GREENCastle ELEMENTARY SCHOOL

MANDATORY REFERRAL NO. MR2024001

RE: Mandatory Referral No. MR2024001
Greencastle ES Addition

Figure 3: Proposed Site Plan

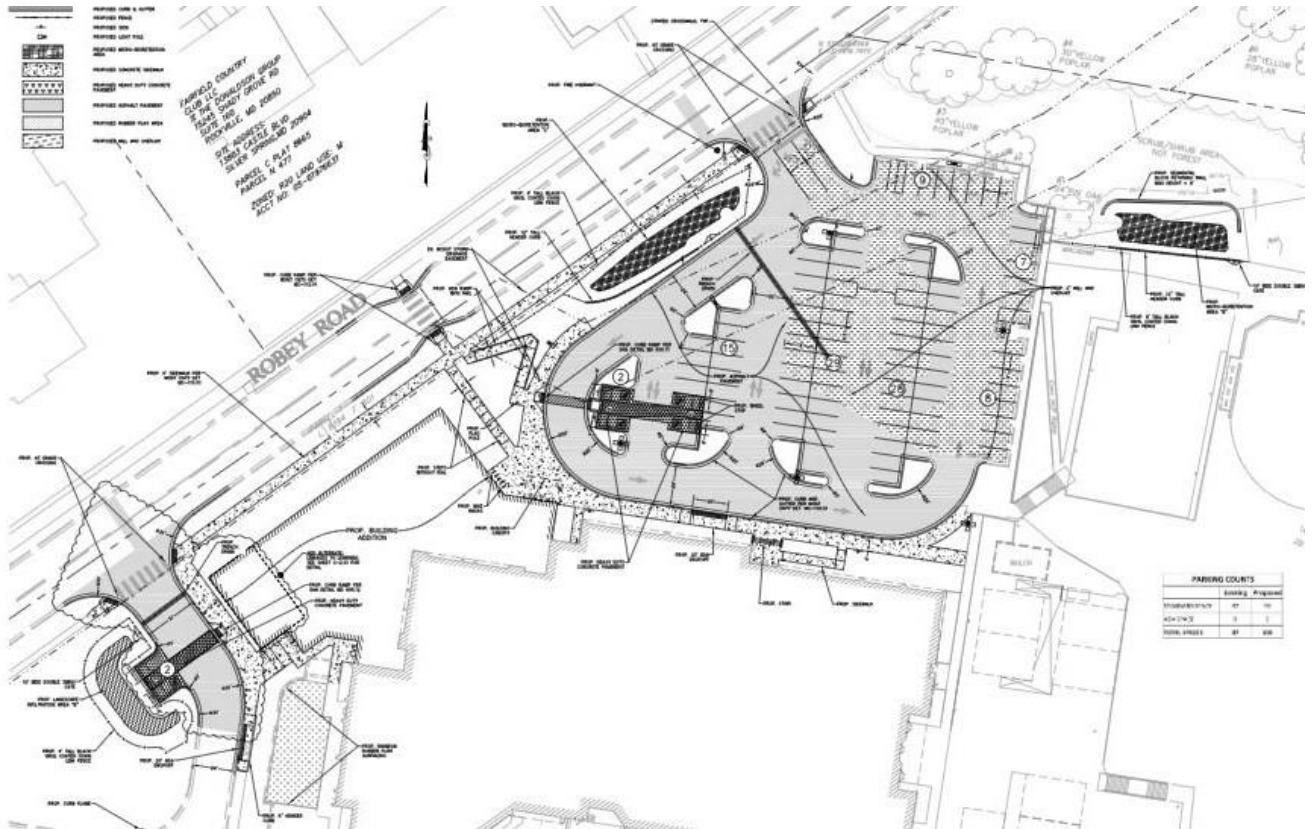
to the easternmost egress and ingress point, eliminating the need for the school bus loop. Eliminating the westernmost curb cut will reduce vehicular conflict with pedestrians and bicyclists and lengthen the parent queue to keep vehicles from backing out onto Robey Road.

Pedestrian access will be improved by adding a 6-foot sidewalk along the Subject Property's frontage. Outside of Robey Road and the pedestrian path to Gateshead Manor, the Site is hemmed in on the eastern and southern faces by stream valleys and forests.

MCPS should coordinate with MCDOT to improve pedestrian safety and access to the school from the opposite side of Robey Road. One mid-block crossing exists from the existing curb cut to the pick-up/drop-off turnaround. Planning Staff recommend the removal of the current curb cut for the mid-block crossing and relocating it closer to the new driveway entrance. Additionally, Staff recommends that MCPS work with MCDOT on including a raised crosswalk at this location and across the new driveway entrance.

- Construct a 6-ft wide sidewalk along the Robey Road frontage and a connecting route to this facility into the site.
- Reduce the reconfigured ingress and egress point to two lanes with a tightened curb radius.
- Provide pedestrian access from the handicap ramp at the back side of the parking lot to the existing path at the back of the school that leads to Gateshead Manor Way.
- Integration of curb extensions to the existing mid-block crossing to facilitate better pedestrian safety.
